VARIANCE REQUESTED
 PROPOSED REDUCTION OF THE 25' REAR SETBACK REQUIREMENT TO 19' IN ORDER TO ALLOW CONSTRUCTION OF A SCREENED ROOM.

VARIANCE DRAWING FOR
EDWARD KOZOL
 LOCATED IN LAND LOT 744 OF THE 17th DISTRICT
 2nd SECTION, COBB COUNTY, GEORGIA
 3747 TREBOURNE SQUARE, SMYRNA, GEORGIA

PETITION No.: V-16

Application for Variance

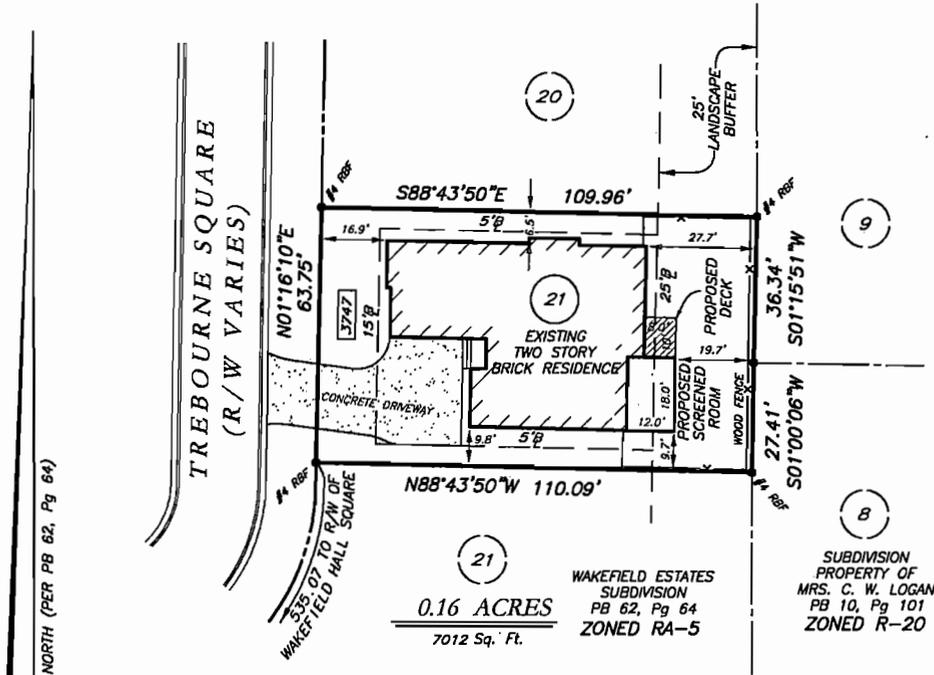
SITE PLAN REVIEW: If this variance request is approved, a subdivision plat revision must be recorded prior to the issuance of the certificate of occupancy showing all improvements on the lot along with any approved setback reductions, and referencing the variance case in the standard plat revision note. The surveyor must submit the plat to the Site Plan Review Section, Community Development Agency for review and approval prior to recording. Call 770-528-2147.

STORMWATER MANAGEMENT: In addition to exceeding the impervious coverage limit for this parcel, the proposed encroachment into the landscape buffer will place the footings for the new porch and deck addition within 3 feet of the existing drainage swale located at the rear of this parcel. The Stormwater Management Division cannot support permitting a structure closer than 10 feet from this swale.
